**Petition for Waiver or Suspension of Hawaii Administrative Rules
§15-217-55(k)(2) of the Mauka Area Rules for 801 South Street Project,
Development Permit No. KAK 12-109**

Staff Report
October 7, 2015

T_{vis} = Visible light transmittance of window glazing

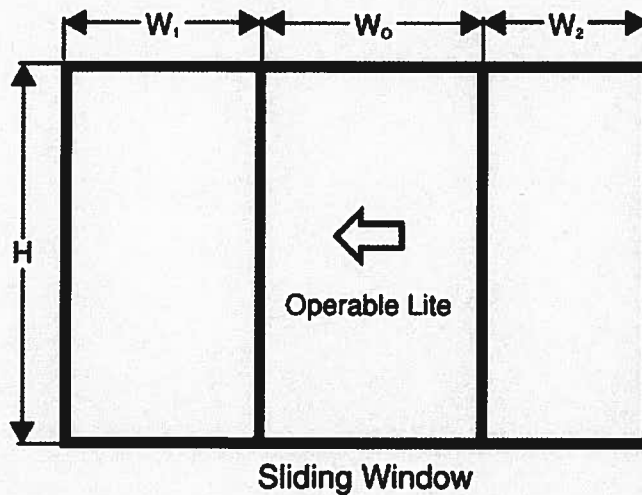
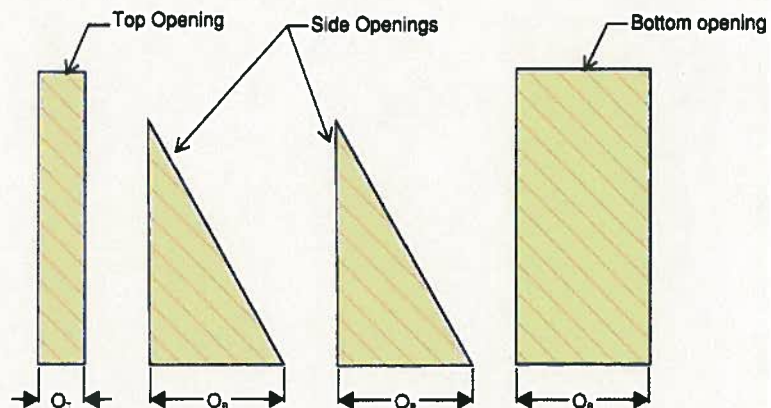
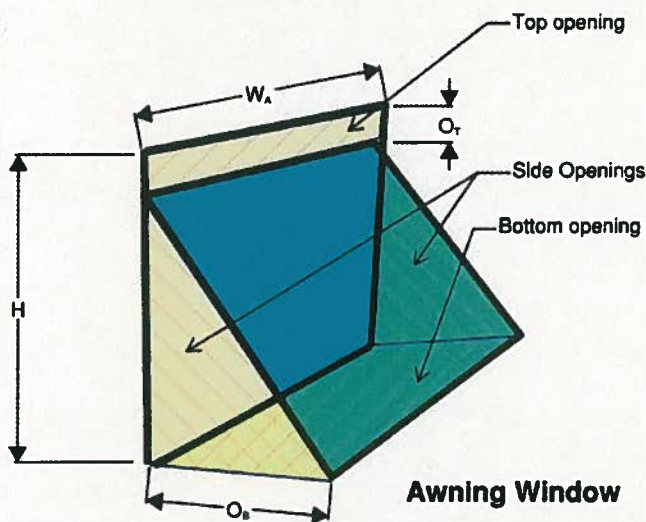
Assuming that the VLT of a glass window or sliding door assembly could be calculated, HCDA staff had some questions regarding the VLT calculation presented by Downtown. Reviewing the calculations, HCDA staff is unable to determine if the window and door areas used in the calculation are inclusive of the window or door frame or exclusive of the frames. This will have impact on the weighted average VLT because the area of the glazing portion is smaller than the area of the window assembly including the frame. Since the VLT of the frame is 0%, inclusion of the frame in the area of the window would have an effect on the weighted average VLT. Similarly, the assumption in calculating the weighted average VLT of the sliding door appears to half the VLT of the glazing. *To HCDA staff's knowledge, there is no industry standard that shows that the VLT of two panels of glazing separated by approximately the width of the frame is half the VLT of the glazing itself.* Given this lack of information in the calculation provided by Downtown, HCDA staff cannot find the methodology credible. Additionally, given the lack of information provided by Downtown, HCDA staff cannot ascertain that the weighted average VLT of the system is above 50%. Since the calculated average VLT for the sliding doors and windows is 50.5%, which is marginally above the required 50%, even a small change in any of the parameters discussed above could lower the average VLT. In addition, the calculation provided by Downtown does not meet the VLT for ground floor windows and glass sliding doors in the Project, which is required by the Mauka Area Rules to be 70% or higher. There is no provision in the Mauka Area Rules for an average VLT for all the windows and glass doors in a project.
